L-2023-012  
10 CFR 50.90  
March 15, 2023

RE: Seabrook Station  
Docket No. 50-443  
Renewed Facility Operating License No. NPF-86

License Amendment Request 23-01, Remove Period of Applicability (POA) from Pressure-Temperature Limits (PTL) and Low Temperature Overpressure Protection (LTOP) Curves

### License Amendment Request 23-01, Revise Pressure-Temperature Limits (PTL) Curve Service Period Based on Surveillance Capsule Dosimetry Analyses

FIGURE 3.4-2

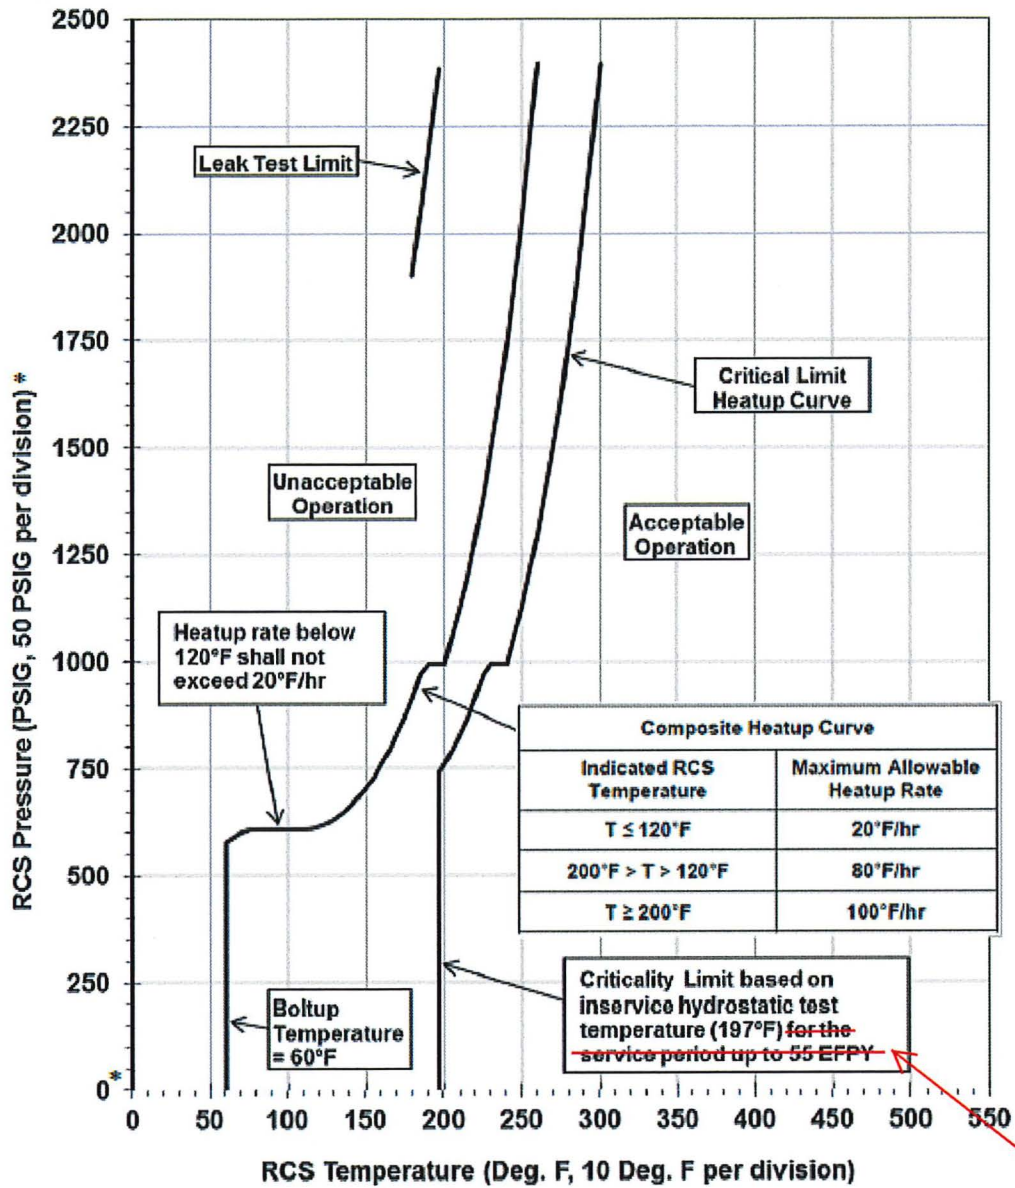
### 2.2.2 Seabrook TS 3.4.9.1, Figure 3.4-2, Reactor Coolant System Heatup Limitations - Applicable to 55 EFPY, specifies:

- 55 EFPY as the POA for the ART limit material property basis,
- 55 EFPY as the POA for the RCS pressure versus temperature curves,
- 55 EFPY as the POA (aka service period) for the criticality limit based on the inservice hydrostatic test temperature (197°F)
- 55 EFPY as the POA identified in the TS Figure title.

The proposed change revises Seabrook TS 3.4.9.1, Figure 3.4-2, by removing 55 EFPY from the figure title and from all references in the figure drawing, and related editorial changes. Attachment 1 provides the Figure 3.4-2 markup to show the proposed change.

~~Curves applicable for the first 55 EFPY and contain margins for possible instrument errors~~

Remove

FIGURE 3.4-3  
REACTOR COOLANT SYSTEM COOLDOWN LIMITATIONS - APPLICABLE UP TO 55 EFY

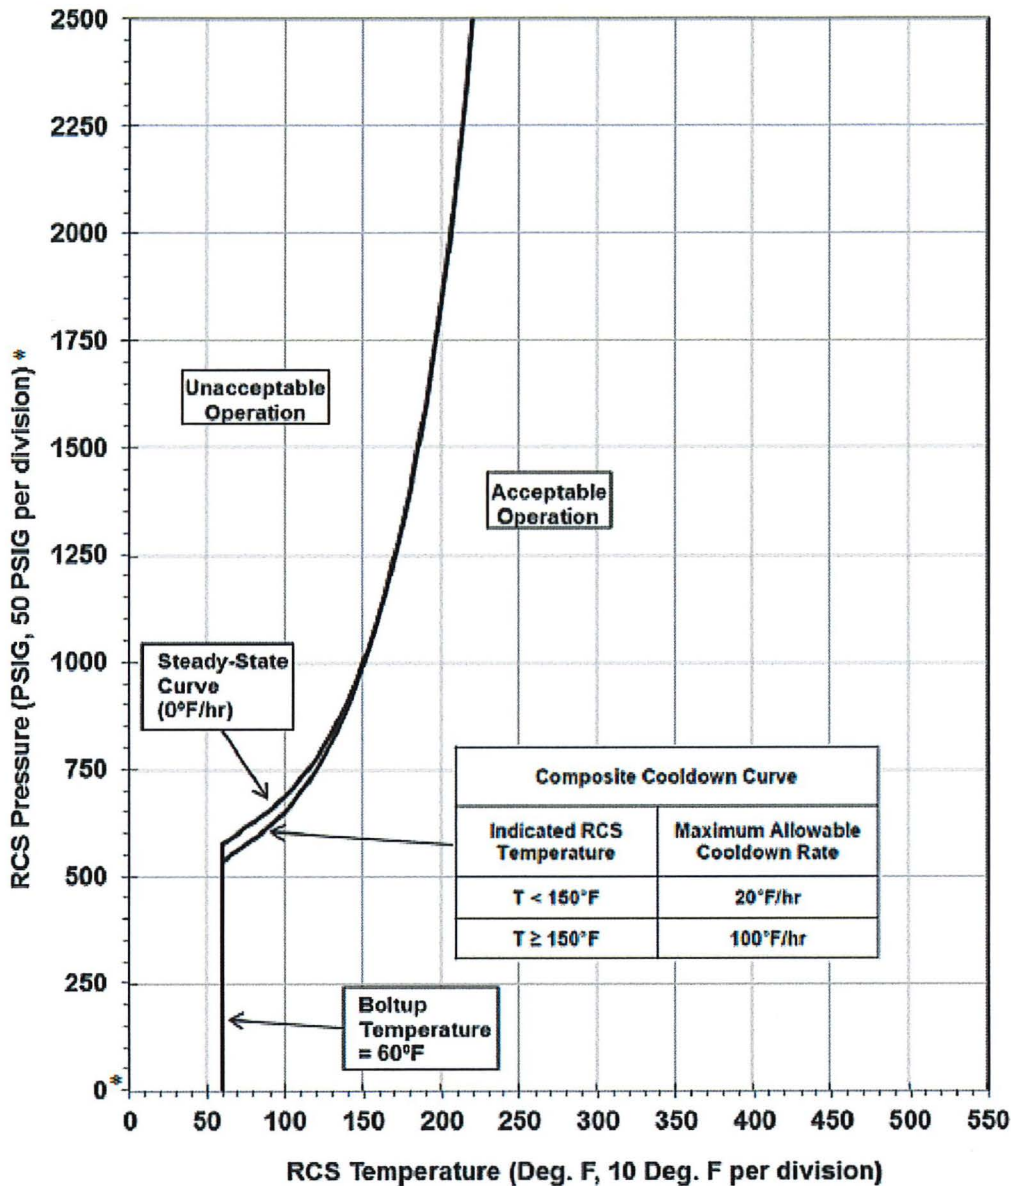
### 2.2.3 Seabrook TS 3.4.9.1, Figure 3.4-3, Reactor Coolant System Cooldown Limitations - Applicable to 55 EFPY, specifies:

- 55 EFPY as the POA for the limiting ART material property basis,
- 55 EFPY as the POA for the RCS pressure versus temperature curves,
- 55 EFPY as the POA identified in the TS Figure title.

The proposed change revises Seabrook TS 3.4.9.1, Figure 3.4-3, by removing 55 EFPY from the figure title and from all references in the figure drawing, and related editorial changes. Attachment 1 provides the Figure 3.4-3 markup to show the proposed change.

Curves applicable for the first 55 EFY and contain margins for possible instrument errors

Remove

FIGURE 3.4-4 MAXIMUM ALLOWABLE PORV SETPOINTS FOR COLD OVERPRESSURE PROTECTION SYSTEM

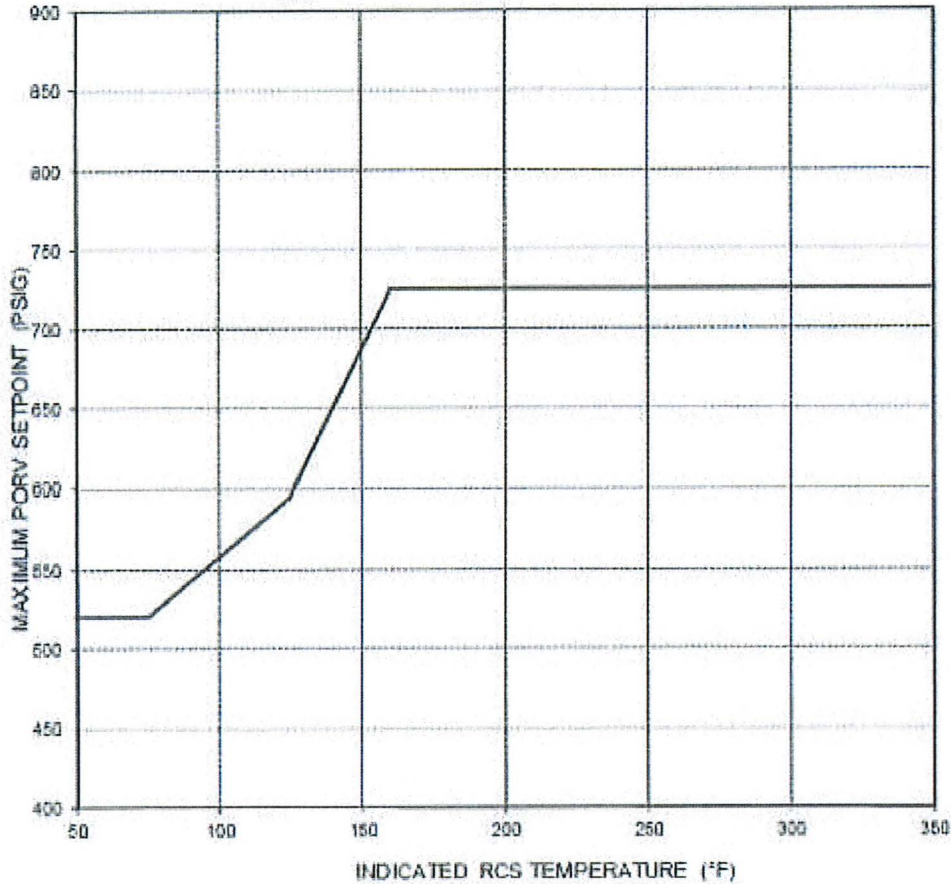
### 2.2.4 Seabrook TS 3.4.9.1, Figure 3.4-4, RCS Cold Overpressure Protection Setpoints, specifies:

- 55 EFPY as the POA for the PORV setpoint versus RCS temperature curve.

The proposed change revises Seabrook TS 3.4.9.1, Figure 3.4-4, by removing 55 EFPY from all references in the figure drawing, and related editorial changes. Attachment 1 provides the Figure 3.4-4 markup to show the proposed change.

~~VALID FOR THE FIRST 55 EFY, MAXIMUM SETPOINT ACCOUNTS FOR INSTRUMENT UNCERTAINTIES~~
